**RFT25-06-1 - City Hall 2nd Floor Renovation and Washrooms Plumbing
Replacement**

Addendum# 1

May 2, 2025

Uptown Parking Map

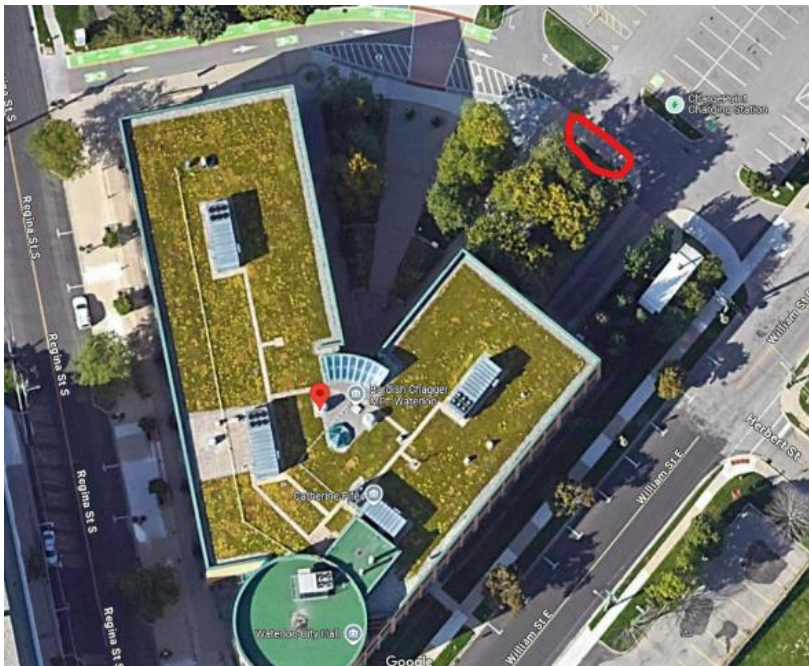
Please confirm where waste and recycling containers can be located on site.

See below picture with marked location:

Project No. 23115	Drawing No. A101
-----------------------------	----------------------------

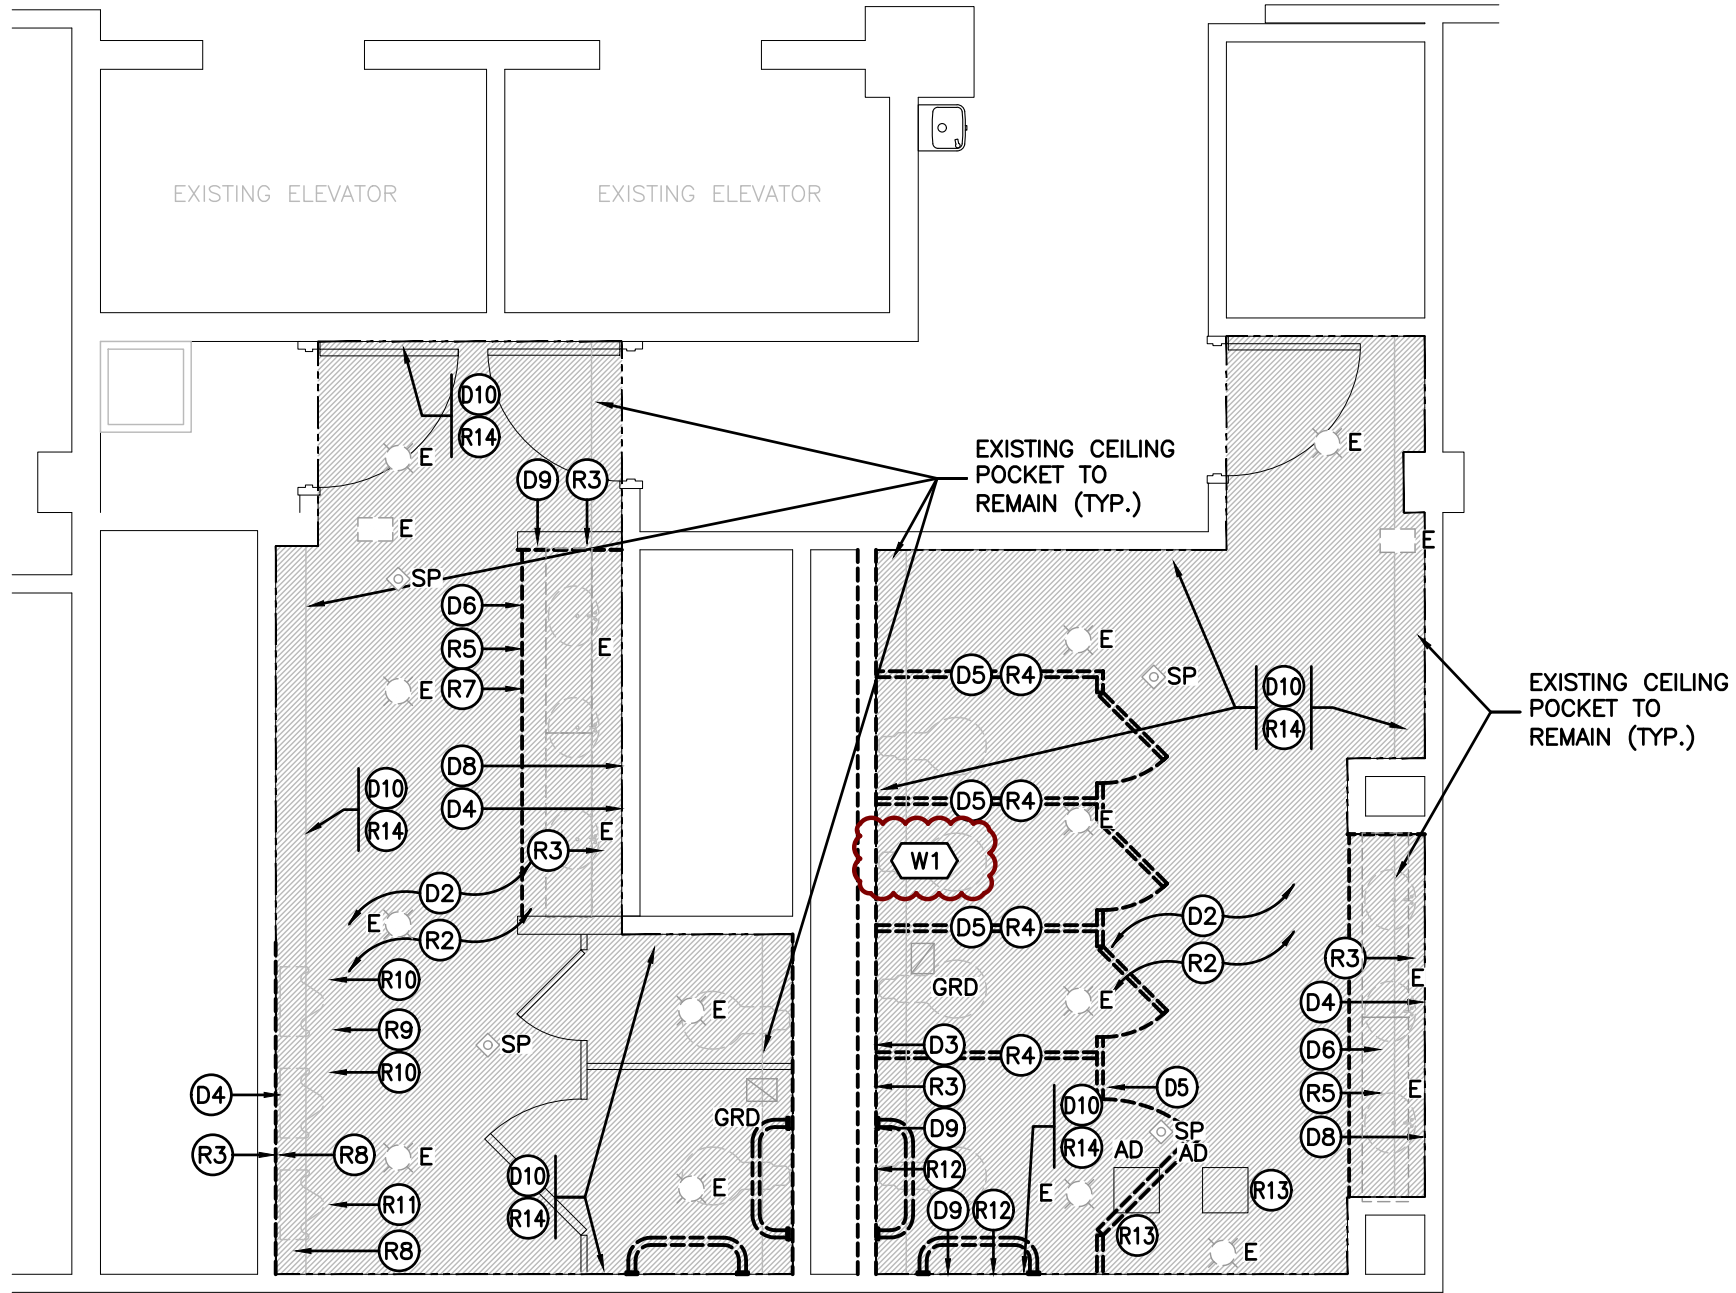
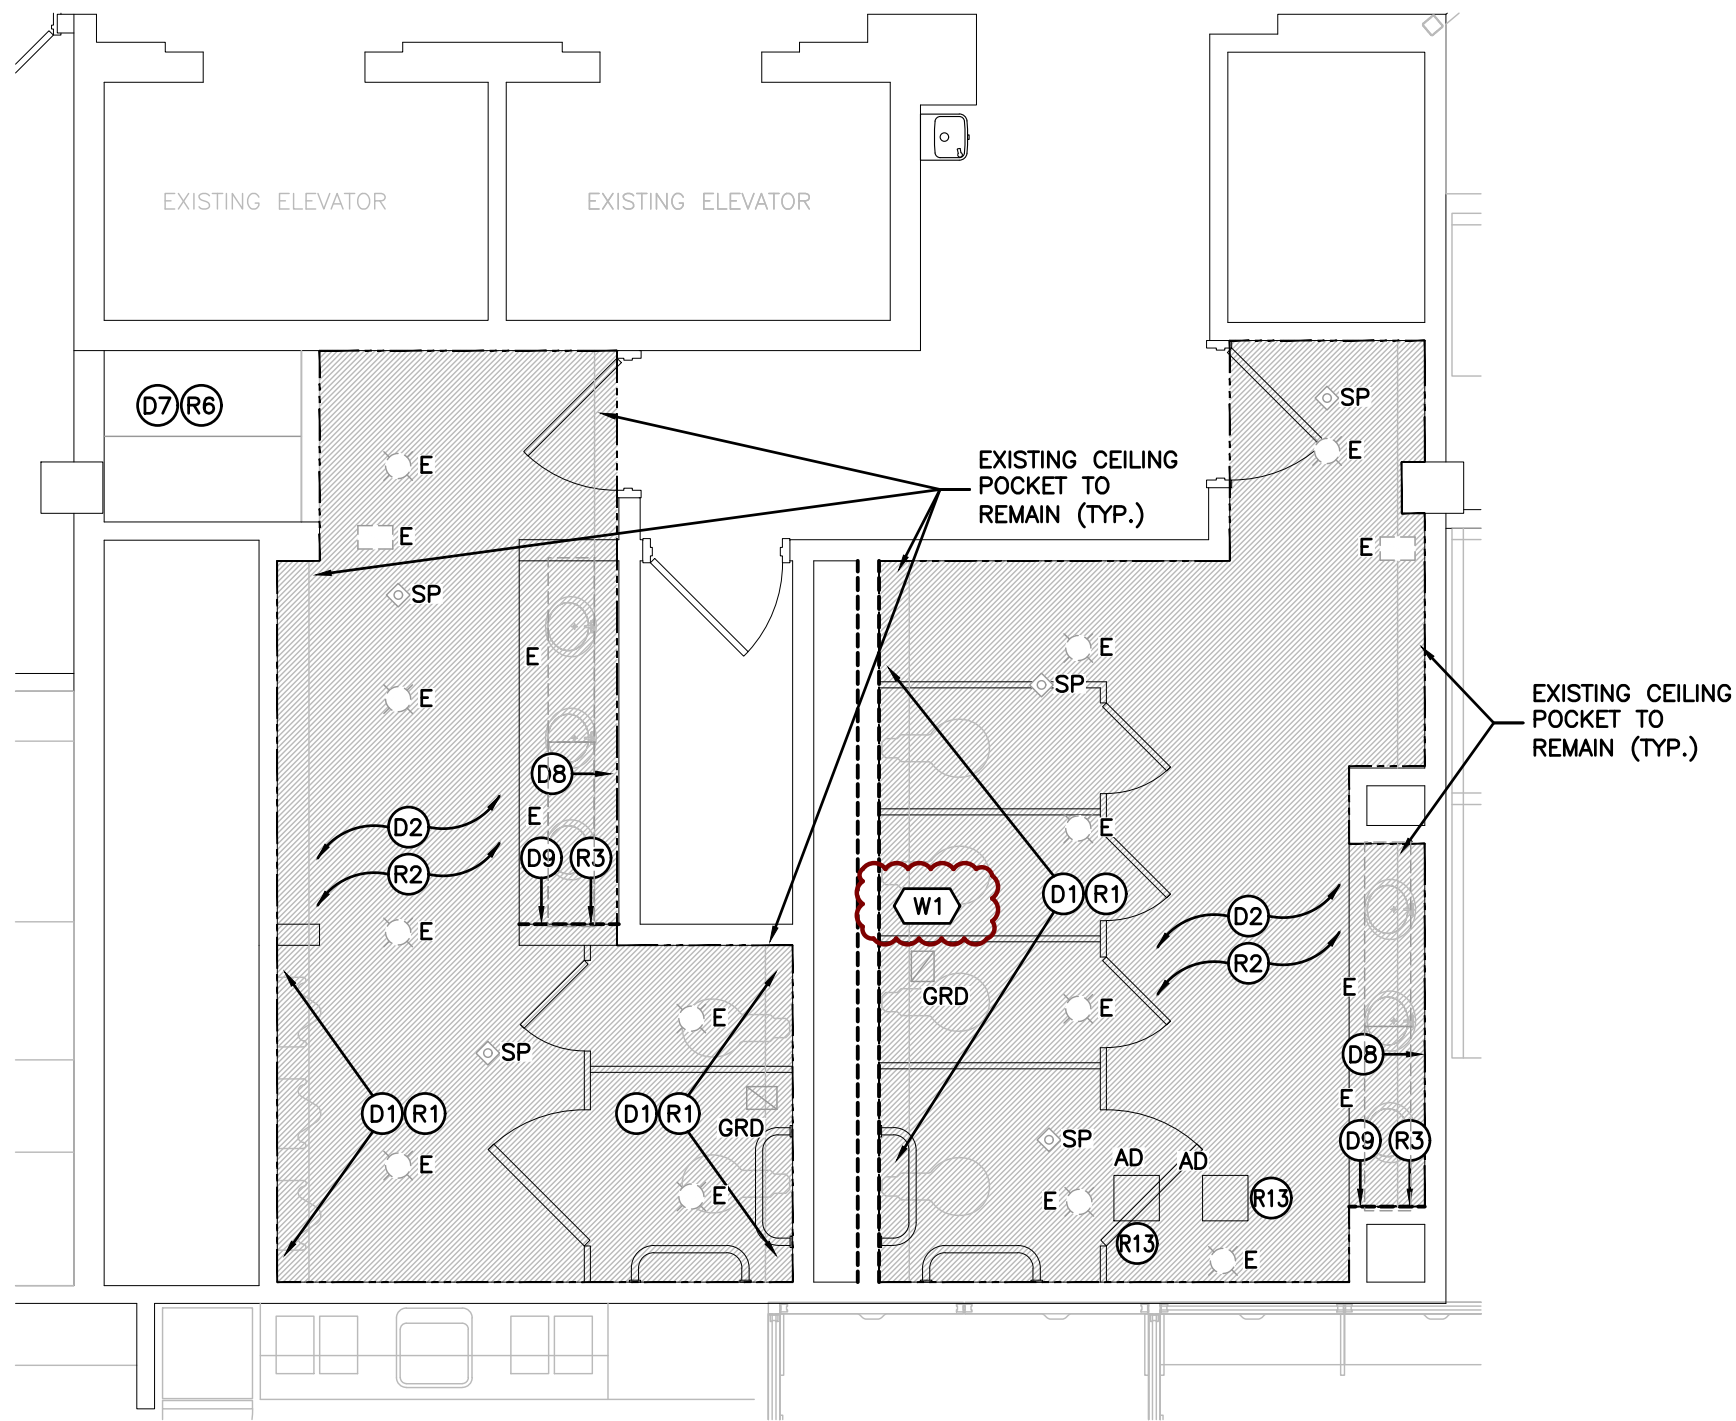
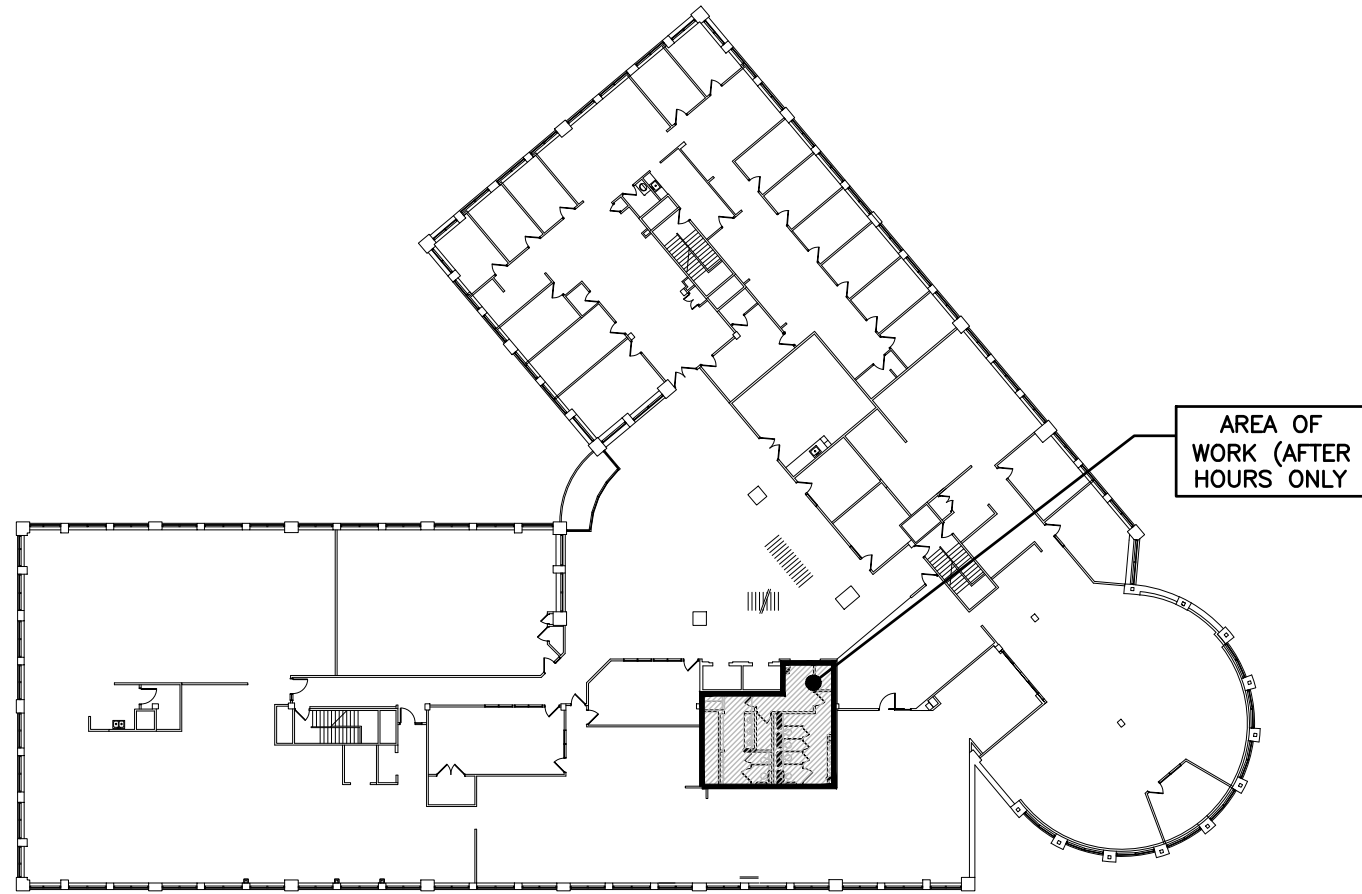
- 1.0 Reference Attached Reissued Phase 1 Drawing A101 and Attached Reissued Phase 2 Drawing A101
 - .1 Revise drawings to include wall assembly schedules.
